COMMISSION ACTION FORM

REQUEST: MAJOR SITE DEVELOPMENT PLAN FOR 2105 COTTONWOOD ROAD

Attachment B-Major Site Development Plan (cont.)

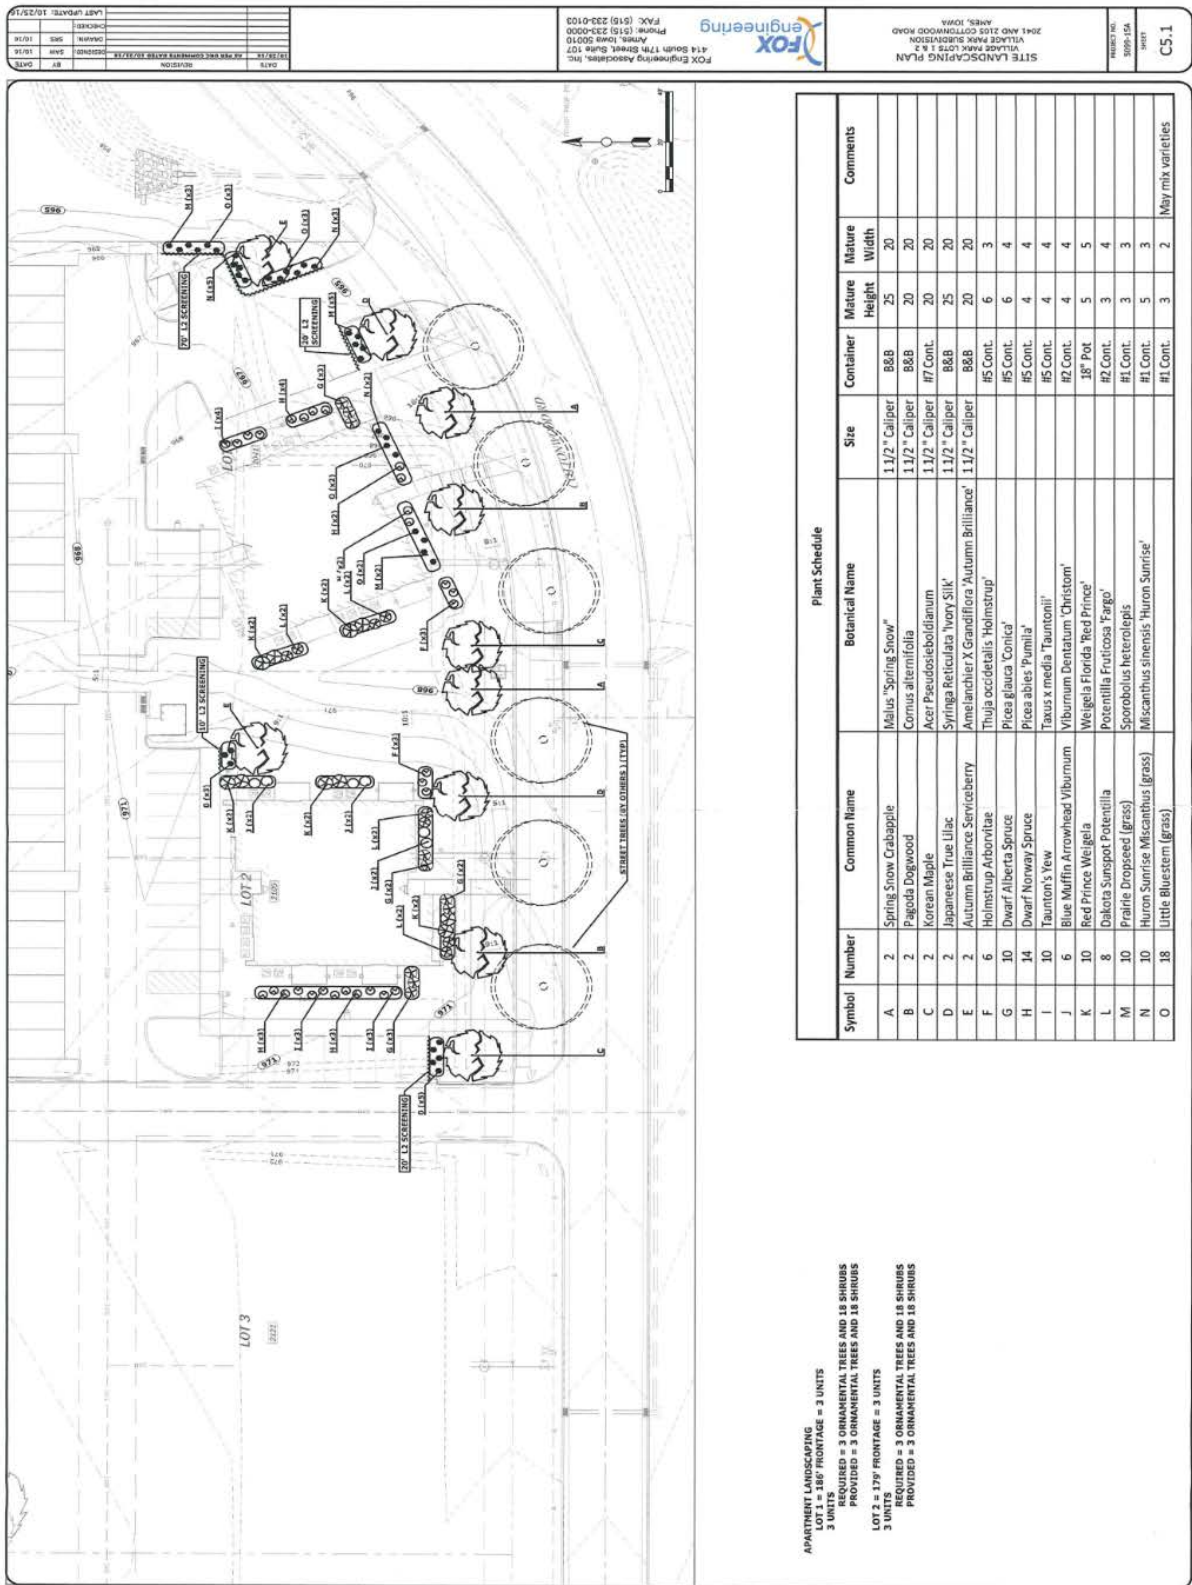
Landscape standards require the installation of building foundation screening along street frontage of an apartment building as well as screening located between the parking area and property lines. As currently configured, the developer seeks approval of alternative parking lot landscaping (29.403(4)(d)) for two issues. The first is to allow substitution of ornamental grasses in lieu of shrubs. The second is to not require screening along the edge parking area on the west side of the site. The developer would be required to plant additional trees and shrubs along the west edge of the site to comply with standard requirements. The developer believes that the grasses provide a desirable aesthetic to the project and provide for a suitable level of screening. Grasses during the summer months provide effective screening, but in the winter months there is likely no screening as the grasses are cut to allow them to regrow in the spring. In this situation staff believes they are acceptable due to the low sensitivity of other uses abutting the site. The developer believes the 2nd issue of edge landscaping is also unnecessary along the west property line due to the abutting use of parking at the property line. The screening is likely not a substantial issue of compatibility, but an additional tree could be included to meet the intent of the shading over parking areas. This is a similar request that is part of all four proposed project along Cottonwood.

The developer believes that the intent of the general development standards of the zoning ordinance have been met for the screening of parking areas with a substitute of grasses being proposed as an acceptable alternative to standard perimeter landscaping. The apartment building provides a high degree of separation and screening of the parking and garages in the rear yard from adjoining views, and as viewed from Cottonwood Road. Additional landscaping and landscaping information is

being required and conditioned prior to City Council consideration to add needed perimeter parking landscaping.
